Attachment 5 - Response-to-Comments Table

REVISION		
	name	
drawn	CL & LY	DATE 23 AUG 2024
checked	-	DATE -
approved	-	DATE -
contract no. -		
project no.		
TITLE :		
PROPOSED TEMPORARY PLACE OF RECREATION, SPORTS AND CULTURE (HOBBY FARM) FOR A PERIOD OF 3 YEARS AND ASSOCIATED FILLING OF LAND

SITE LOCATION :		
VARIOUS LOTS IN D.D. 96, SHUN YEE SAN TSUEN, MA TSO LUNG, NEW TERRITORIES		
drawing title.		
FILLING OF LAND PLAN		
drawing no.	rev.	scale
PLAN 5	D	N.T.S.

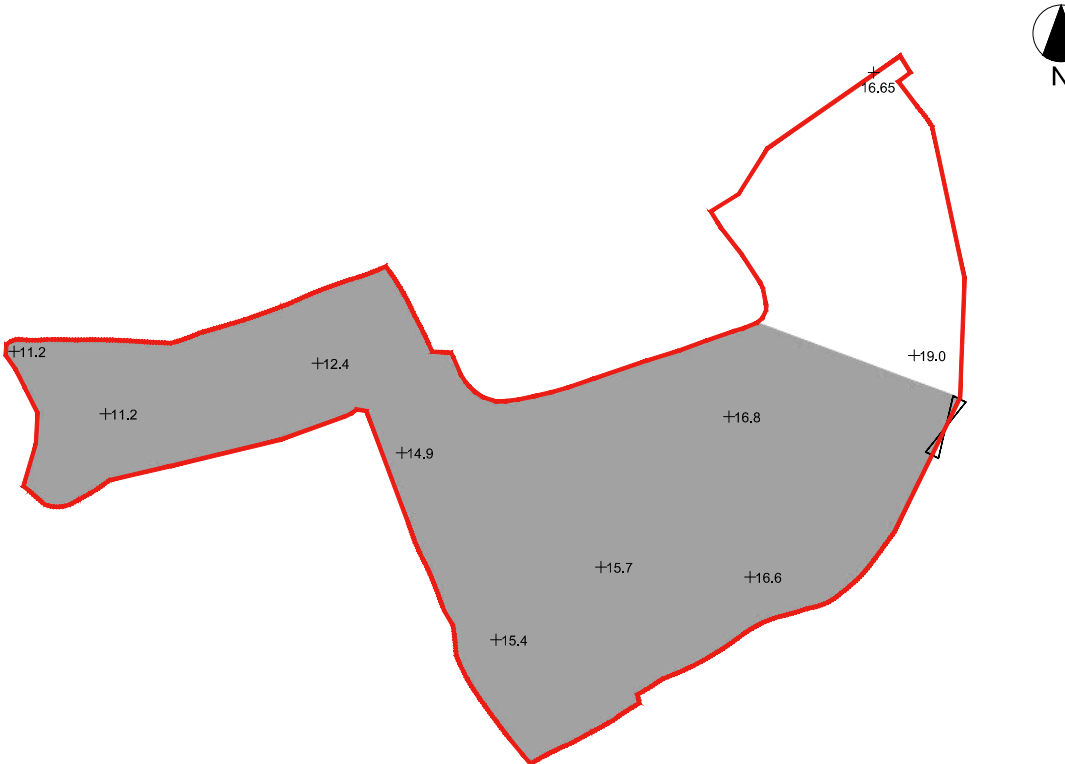
No.	Comments	Responses
1	<p>Drainage Services Department (DSD), dated 15.4.2025</p> <p>(a) Cross-sections under the Appendix A refer. Please indicate the proposed drainage facilities in the cross-section views for our reference. Also, please clarify if hoarding will be erected along the site boundary, which may affect the passing of overland flow. Besides, the proposed formation profile under Section A is missing, please supplement.</p> <p>(b) Please review if the future ground level indicated in the cross-section view align with the level indicated in the "filling of land plan". For example, the proposed formation level in Section B within the application site is below 15mPD, however, it is indicated as around 16.9mPD in the Plan 5. As reflected in Appendix D, the runoff from the catchment area to the south of the application site shall flow through the application site, please ensure the formation land and corresponding drainage facilities would cater such purpose.</p> <p>(c) The existing underground drain DN900 indicated in Appendix B and H is not DSD's facility. You shall properly maintain the section within the application site to ensure its normal operation to convey the flow from the eastern catchment area.</p> <p>(d) Appendix H photo VP7 and VP8 refer. Please validate if it's dimension is aligned with your assumption in the calculation. Also, overgrown vegetation is observed at the discharge point, please carry out regular clearance works to ensure smooth flow path.</p>	<p>(a) Noted. Proposed drainage facilities have been shown in revised drawings of Appendix A Master Layout Plan for your easy reference. Chaining fence / garden wood barrier will be used to define site boundary of this development. There is a gap (i.e. at least 20mm) between chaining fence / garden wood barrier and finished ground surface. This allows overland flow passing through. Under Section A, the proposed formation profile is same as existing ground profile. The ground surface material will be partially filled from soil to concrete.</p> <p>(b) Noted. The levels shown on the Filling of Land Plan (Plan 5) in Appendix A Master Layout Plan have been reviewed and updated. Applicant will ensure the formation land and corresponding drainage facilities would cater such purpose.</p> <p>(c) Noted. Applicant will closely coordinate with nearby villagers to ensure its normal operation to convey the flow from the eastern catchment area. If any blockage of existing underground drain DN900 identified, Applicant / nearby villagers will take necessary action to remove the blockage.</p> <p>(d) Topographical survey has been carried out. River bank level, river invert level and river alignment have been incorporated into site layout. River dimension is aligned with our design assumption. Details refer to topographical survey drawings for that area in Appendix H Site Photos and Topographical Survey. Noted. Applicant will carry out regular clearance works to ensure smooth flow</p>
